CITY OF DALLAS
LANDMARK COMMISSION
Monday, November 6, 2017
AGENDA

BRIEFINGS: AGENDA

Request #s 1, 2, and 3 – Drawing of proposed spindles, brackets, wood shingles, and verge boards.

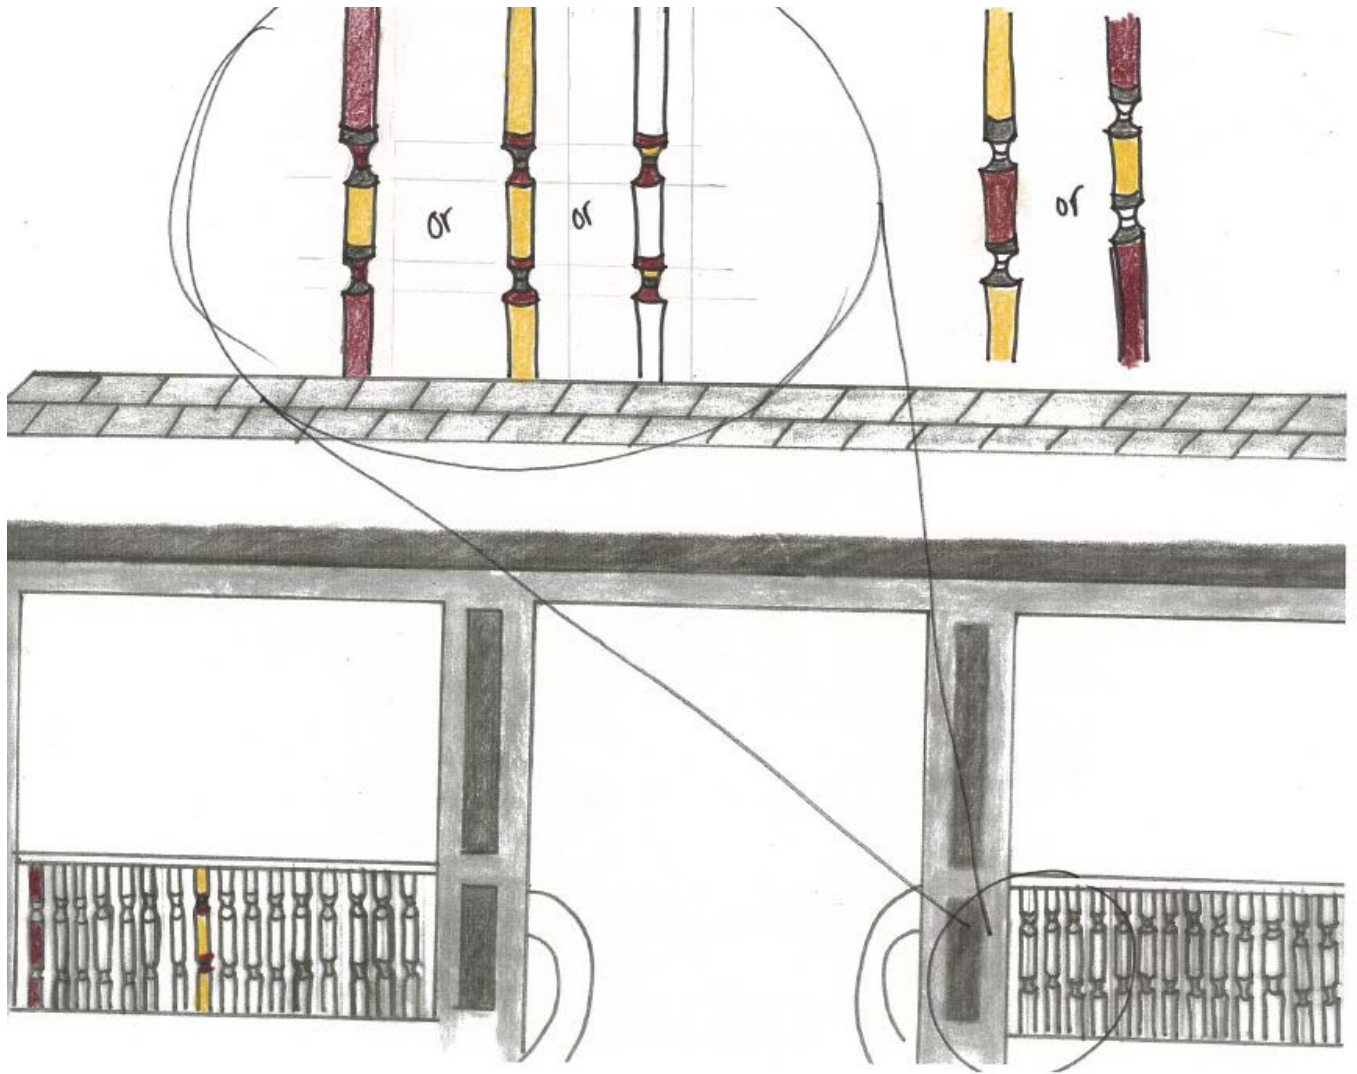
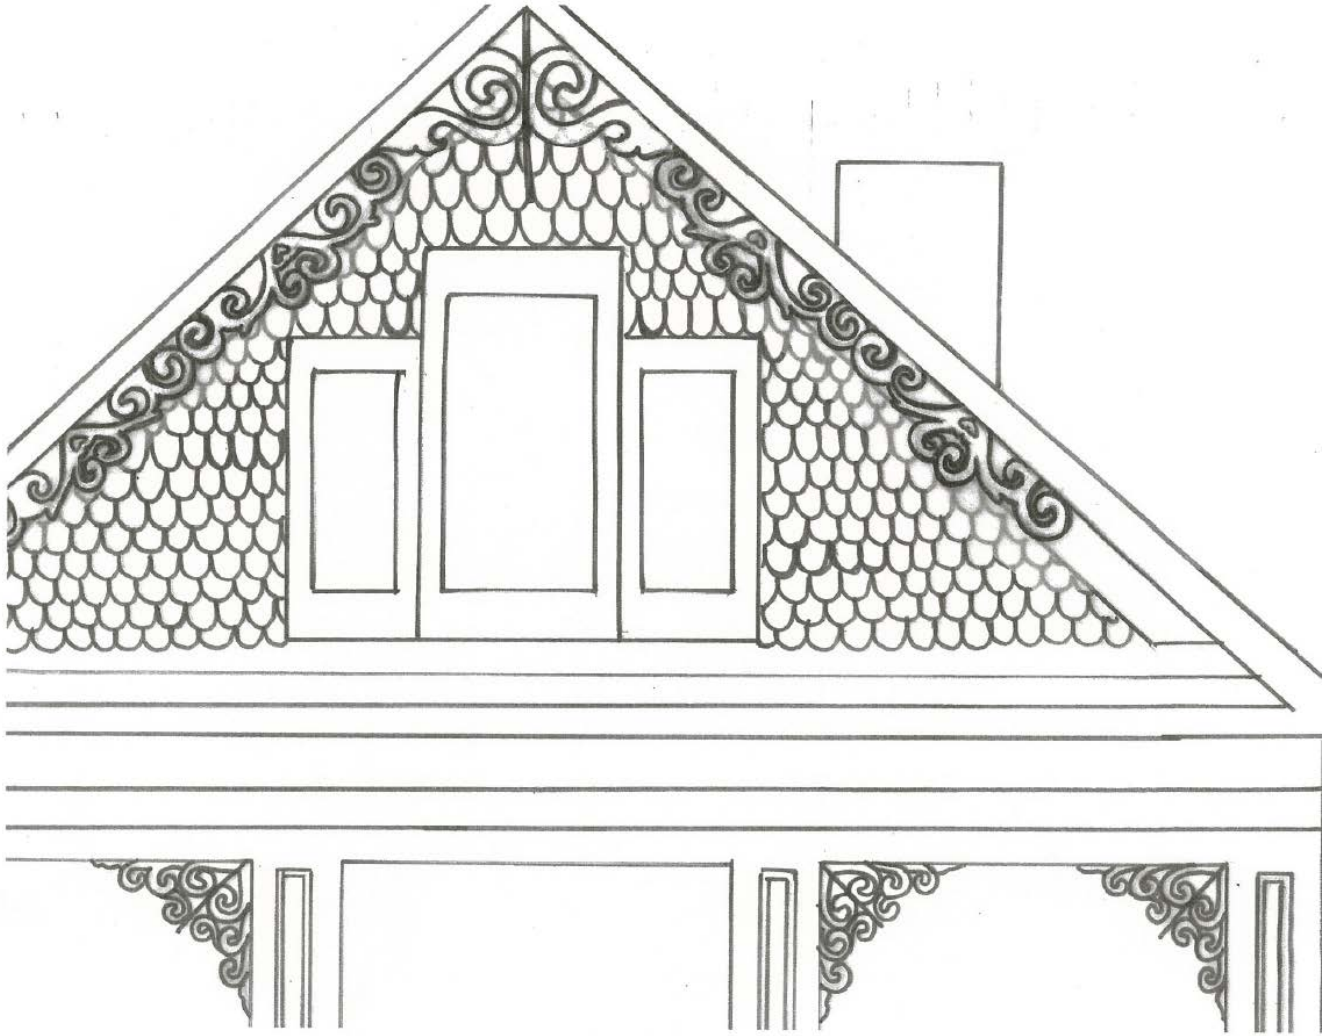
1. Install 3'-0" spindled handrail and decorative brackets on front porch.
2. Install patterned wood shingles on front gable.
3. Install decorative verge board on front gable.
4. Remove boxwood shrubs in front yard.
5. Paint main structure using one body color, one trim color, and three accent colors. Brand: Sherwin Williams. Body - SW 6123 "Baguette." Trim - SW 6385 "Dover White." Accent 1 - SW 6990 "Caviar." Accent 2 - SW 7585 "Sun Dried Tomato." Accent 3 - SW 7048 "Urbane Bronze."

1. Install 3'-0" spindled handrail and decorative brackets on front porch. - Deny without prejudice - Inappropriate.
2. Install patterned wood shingles on front gable. - Deny without prejudice - Inappropriate.
3. Install decorative verge board on front gable. No quorum, comments only. - Deny without prejudice - Inappropriate.
4. Remove boxwood shrubs in front yard. - Approve – Approve.
5. Paint main structure using one body color, one trim color, and three accent colors. Brand: Sherwin Williams. Body - SW 6123 "Baguette." Trim - SW 6385 "Dover White." Accent 1 - SW 6990 "Caviar." Accent 2 - SW 7585 "Sun Dried Tomato." Accent 3 - SW 7048 "Urbane Bronze." – Task Force did not vote on this request.

Site survey showing the original accessory structure

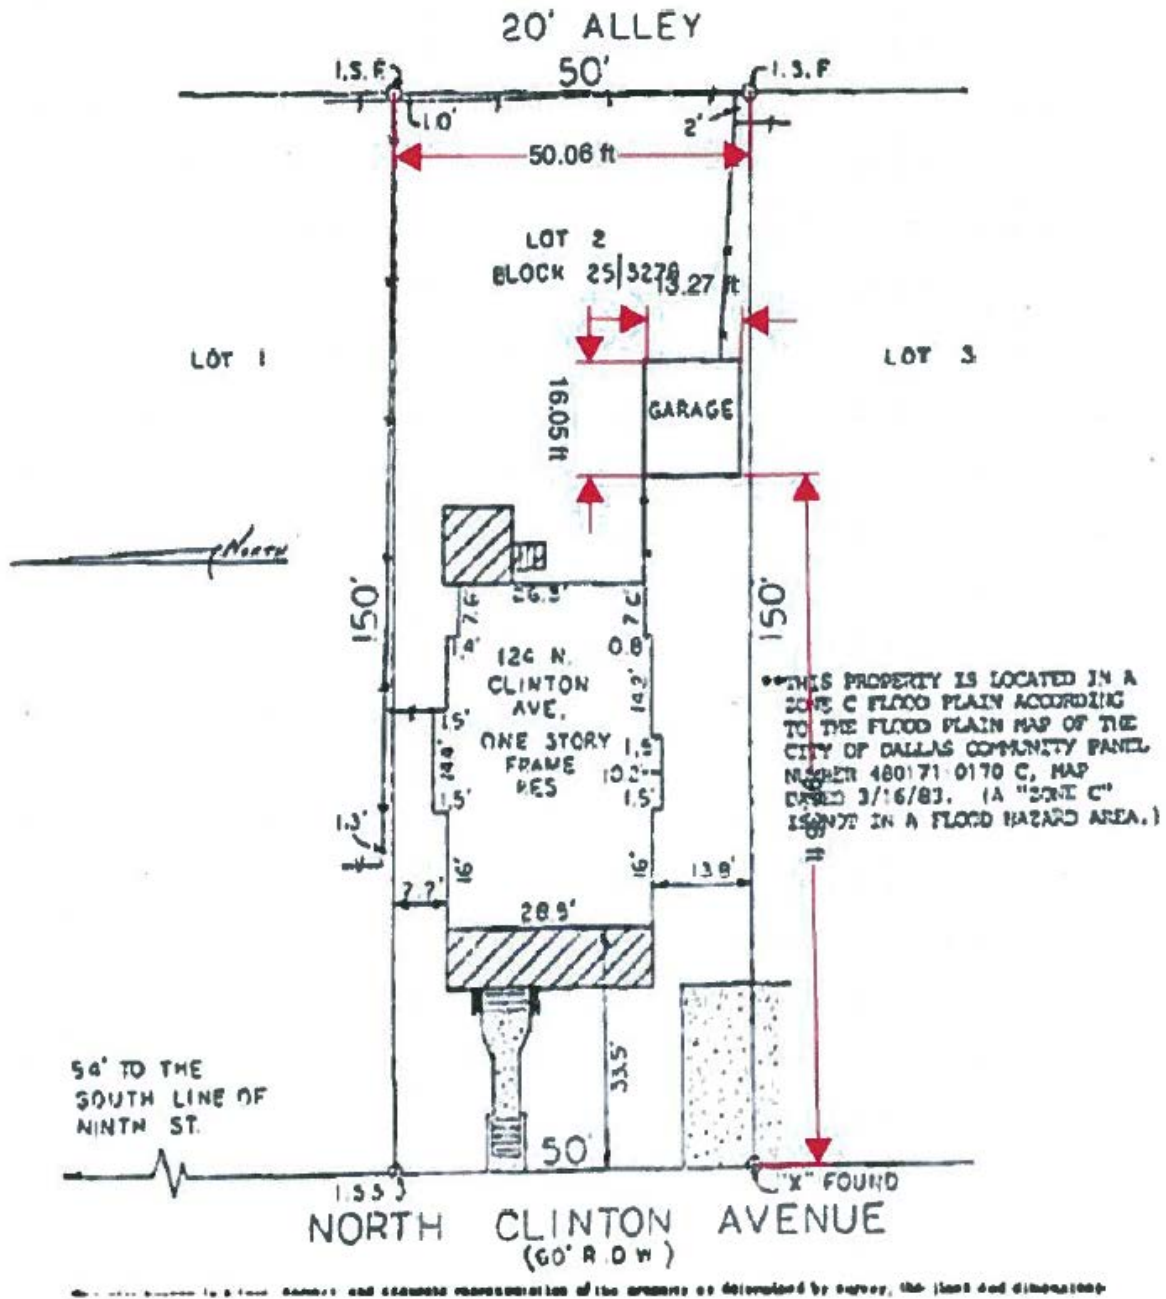
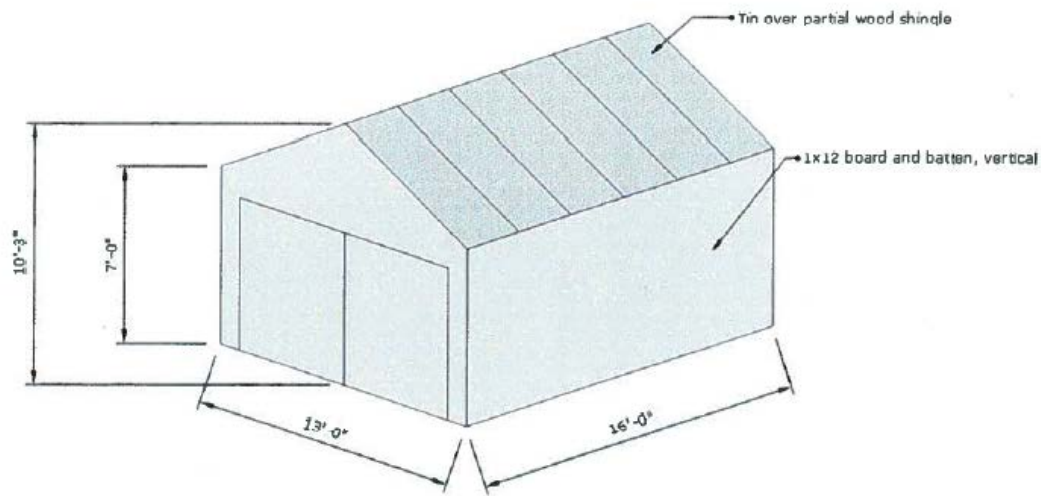
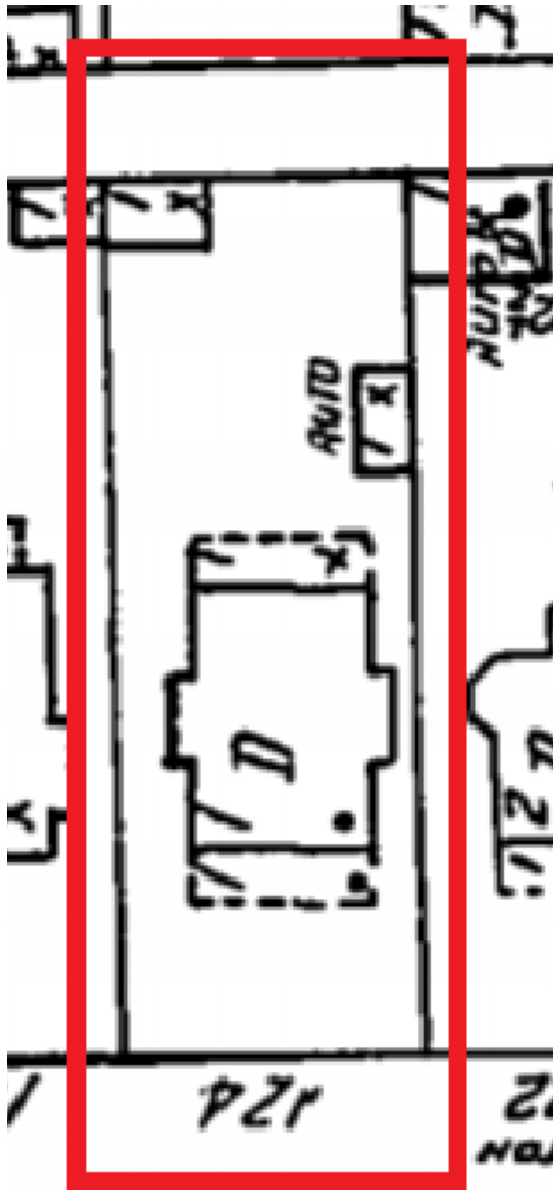
Demolish accessory structure using the standard "replace with more appropriate/compatible structure." Work completed without a Certificate of Demolition.

Demolish accessory structure using the standard "replace with more appropriate/compatible structure." Work completed without a Certificate of Demolition—Deny without Prejudice – The completed work does not meet the standards in City Code Section 51A-4.501(h)(4)(A) because the applicant did not meet the burden of proof required to justify the work since no detailed information was submitted for the original structure.

Demolish accessory structure using the standard "replace with more appropriate/compatible structure." Work completed without a Certificate of Demolition - Deny without prejudice - Provide more information.
